IAEA MISSION ON PARTIAL COLLAPSE OF TURBINE HALL ROOF OF UNIT 4

**Chernobyl NPP, Ukraine
03–07 June 2013**

**Review of activities performed by ChNPP and analyses of perspective causes of
the Unit 4 turbine roof failure.**

Figure 1 Turbine Building outside view of area of collapsed wall and roof section

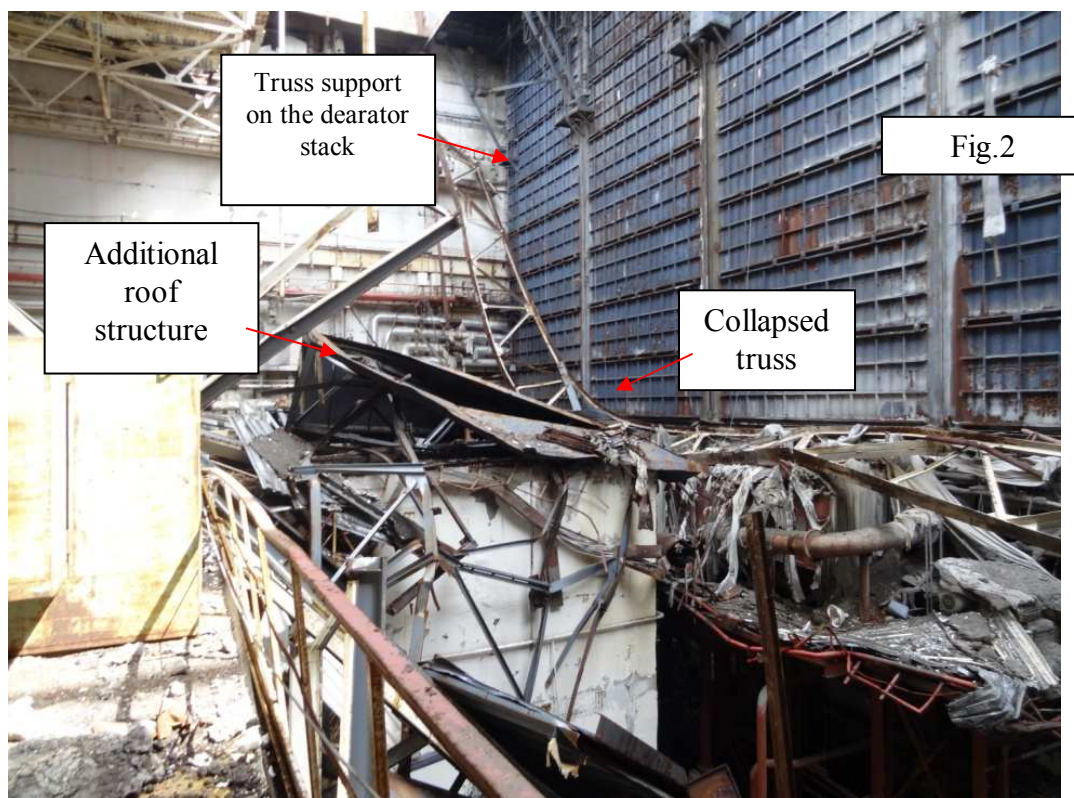
The collapse of the part of the Chernobyl NPP's Unit 4 Turbine Hall roof in axes 50-52 has occurred 12.02.2013 (Figure 1). The survey conducted after the collapse showed that the failure of the truss along gridline 50 (Figure 2) was the cause of the collapse. Truss failure resulted in the collapse of the hinged wall roof panels and additional roof constructions, installed in 1988 above the roof originally constructed in 1983.

Fig.3

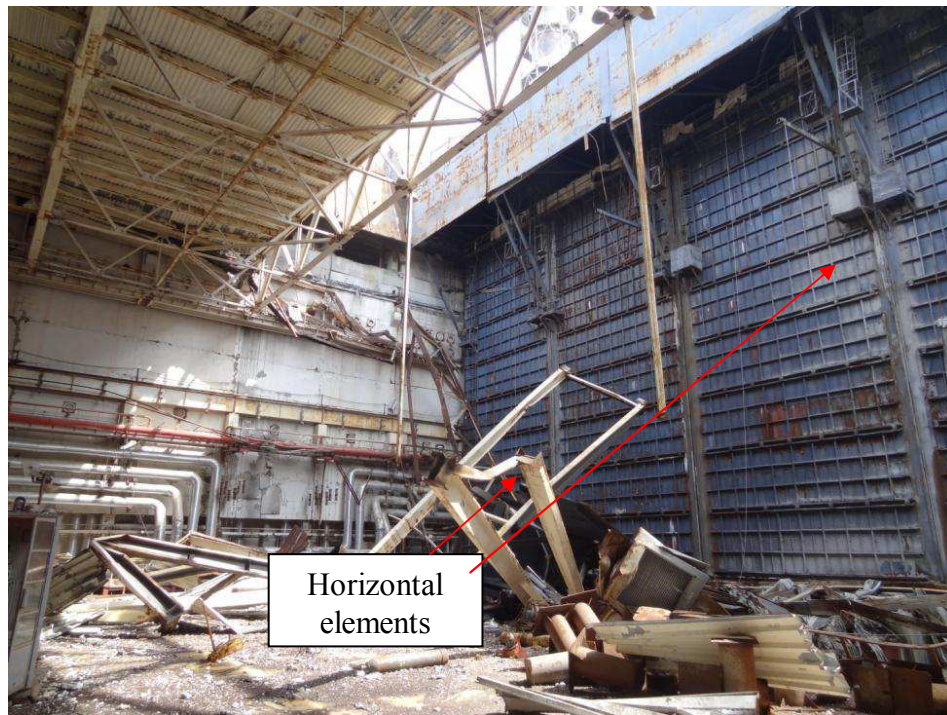
Collapsed roof truss was connected with bracings on the bottom chord with trusses in axes 52. During failure its junctions with bracings were destroyed (Fig. 3)

Figure 4 Turbine Building view from outside of wall panel failure in "high" roof zone next to gridline 50

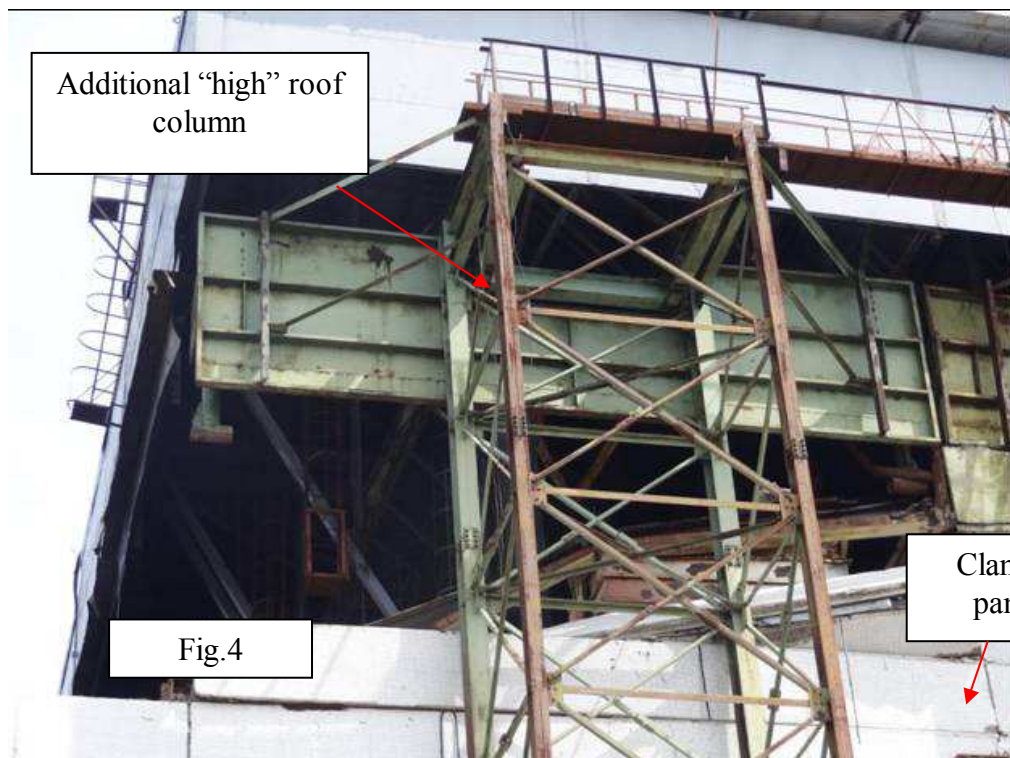
Along with the roof collapse complete or partial collapse of wall panels (~ 20 pieces) occurred in the zone of fallen roof truss support on a column along gridline A. Part of these panels collapsed to the ground, some panels were stuck in unstable position, partly relying on neighboring structures. Another part of the unstable panels has been removed by plant's personnel using the jib crane. Part of the unstable panels were not accessible for the crane due to close location of spatial structure supporting additional "high" roof, built over an intensively damaged roof area of the Turbine Hall after the accident from 26.04.1986.

- In order to avoid overloading of the construction, to dismantle damaged wall panels on row A between the axes 52 - 46 in two phases: within the first phase to dismantle the wall plates between axis 50-52 and in axis 48 and within the second phase to remove all other plates after detailed survey [8].

Figure 7 Damages to ChNPP generation II structures (Units 3 and 4) as a result of the accident

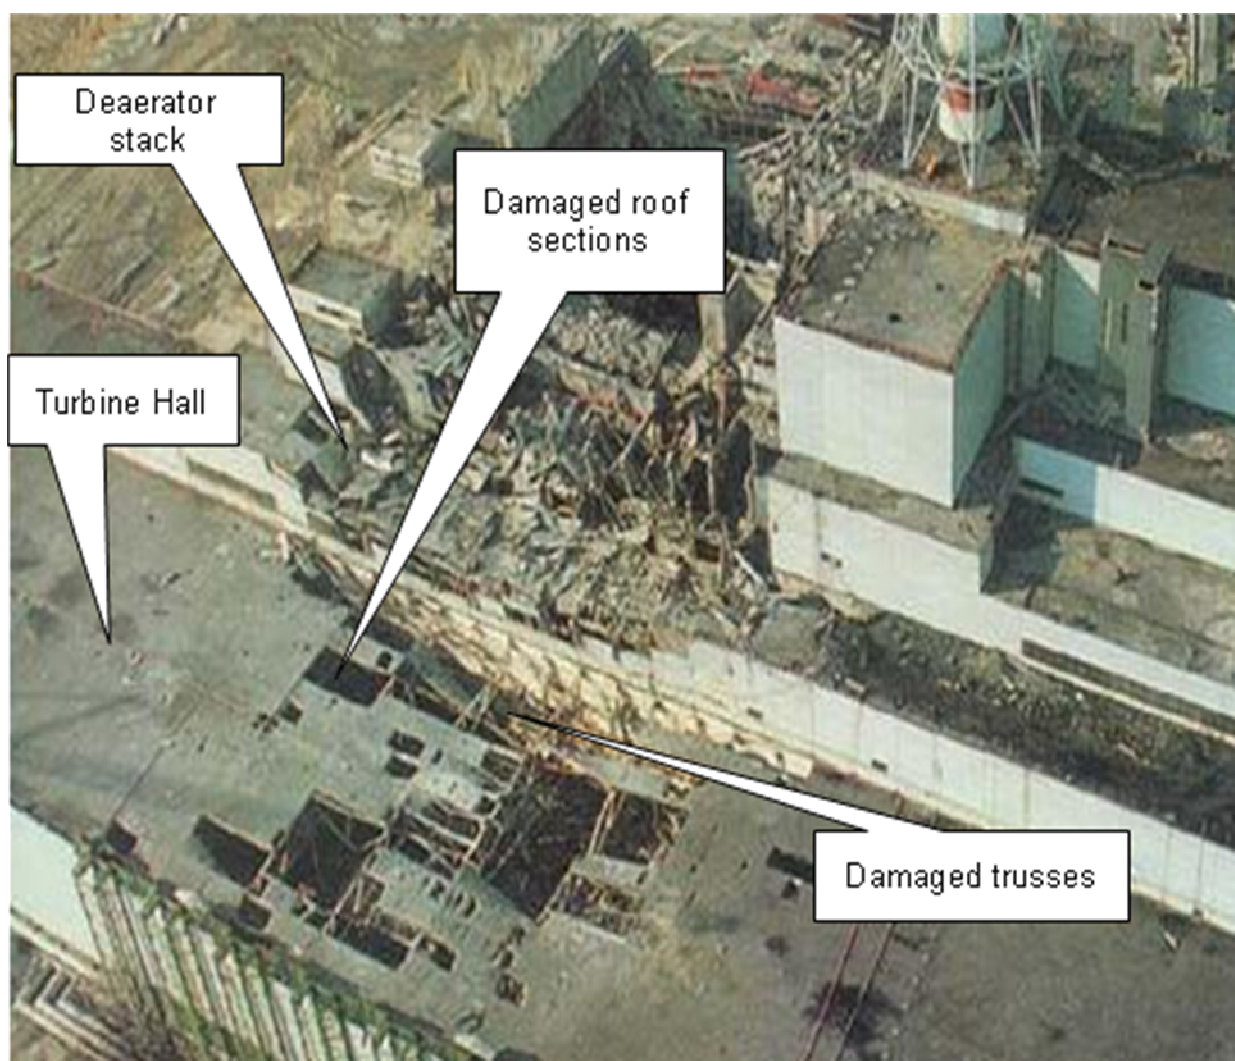
During the 26.04.1986 accident not only Reactor Building, but also some Deaerator Stack and Turbine Hall structural elements were seriously damaged (Figure 7).

Figure 9 Transverse section of second roof structure in “low” roof area

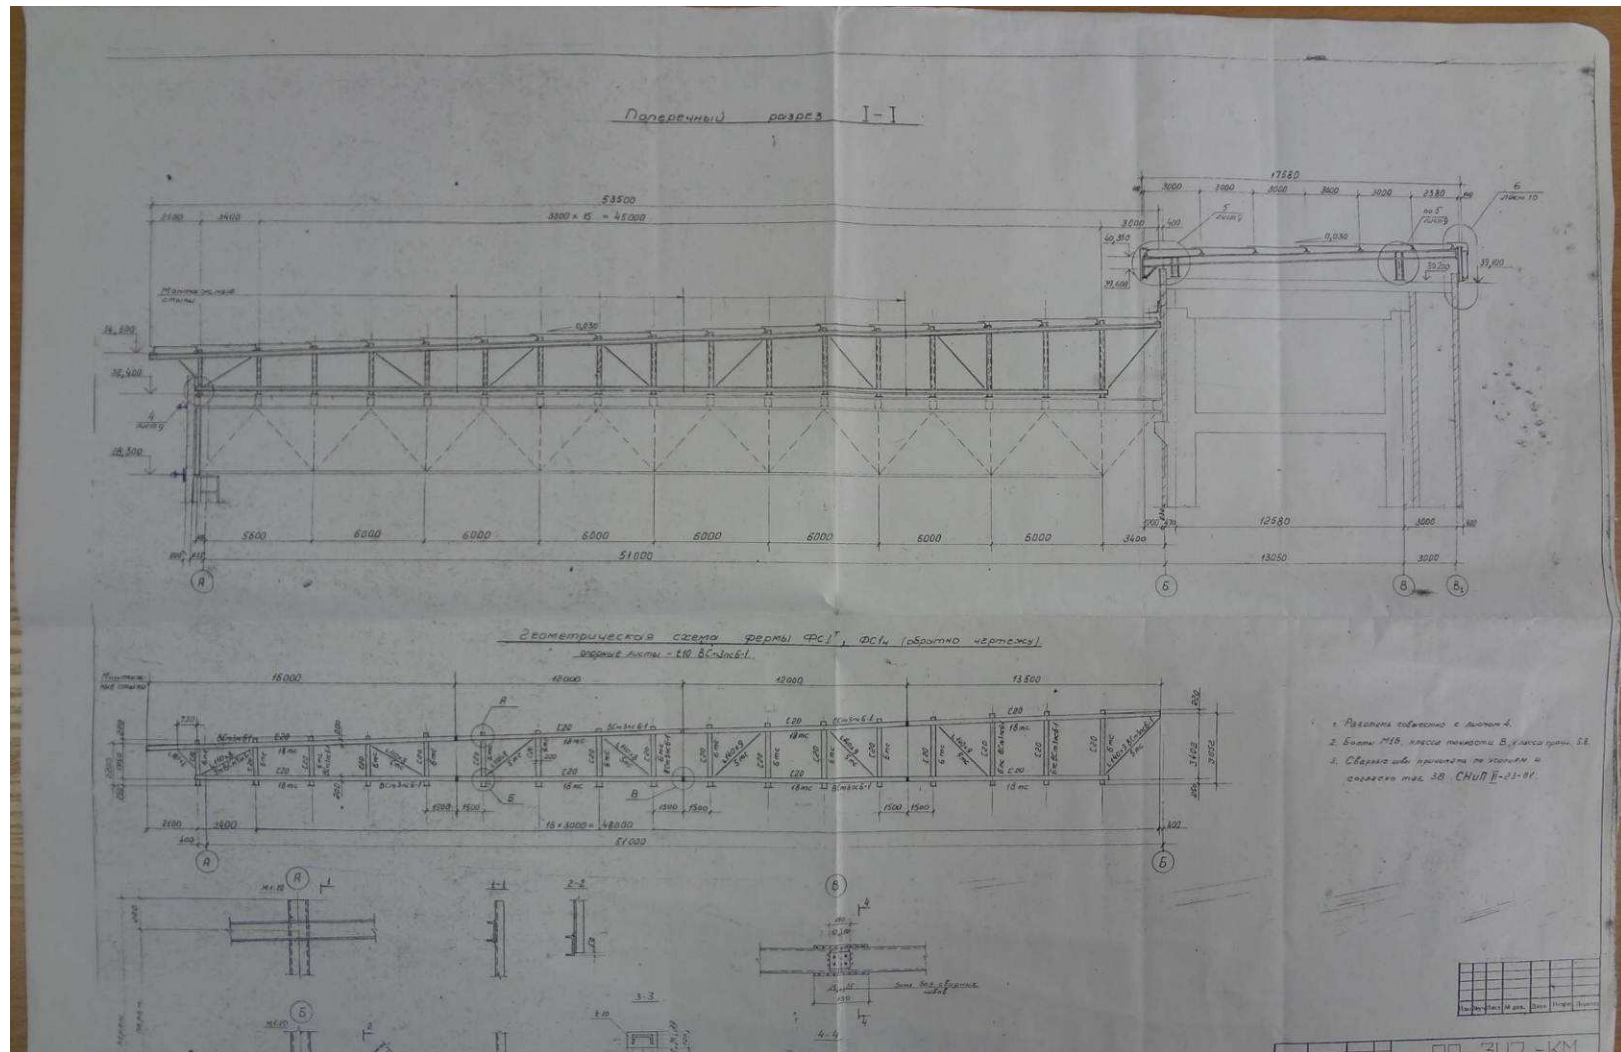
Additional "low" roof was arranged in the area, where the damage severity was less. In this zone original trusses have been kept as the supporting structures for covering. New construction has been installed on the axes of these trusses above the existing roof slab, which included additional metal frames, on which the roof of flat steel sheets stacked overlap has been arranged (Figure 9). In the longitudinal direction the joints between the sheets has been arranged using the roofing iron strips. Also, junction of additional "low" roof to the deaerator stack was covered using the flat strip. There is no data about presence of moisture-proof seals or other means for roofing sheets sealing.

The design calculations that should establish the availability of structural resource to support the second roof and whether this included any reduction of original design snow load are unknown.

It would be prudent to try (again) to obtain full set of as-build design drawings and design calculations from the Designers of Record from 1983 and designer of construction of additional roof performed in 1988 (possibly with involvement of the General Designer - VNIPIET Institute from St. Petersburg). Such design information would significantly contribute to the completeness of actual data required for the further analysis of the turbine hall roof stability and understanding of the conditions impacting on engineering estimate of the life cycle.
